Department of Natural Resources and Mines Mackay District Office

Mine Record Entry

Today the 1st November 2010 an unannounced inspection of South Walker Creek Open Cut was carried out by Safety and Health Inspection Officer Mr Keith Brennan.

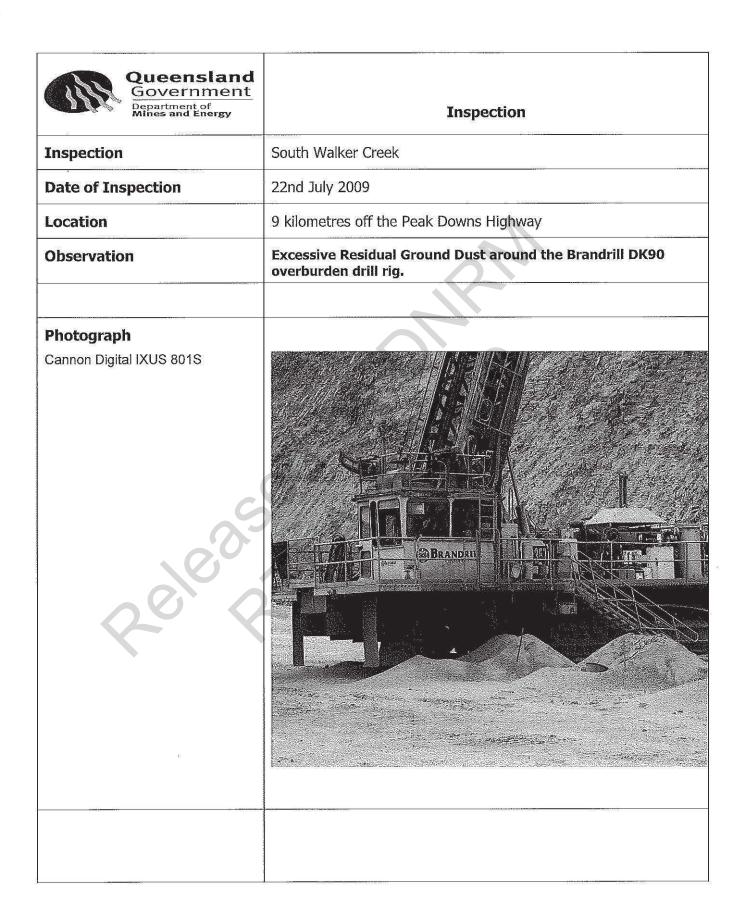
I entered the drill carousel deck and I noticed that the handrail bracket for access off the rear deck was damaged and the handrail could not be secured to the handrails. The lower glass door panel leading to the carousel was damaged and required replacing; a fire extinguisher had no test tag attached. I notified Acting Mining Manager s.73 irrelevant information that unit 78 is to be stood down until satisfactory repairs have been carried out.
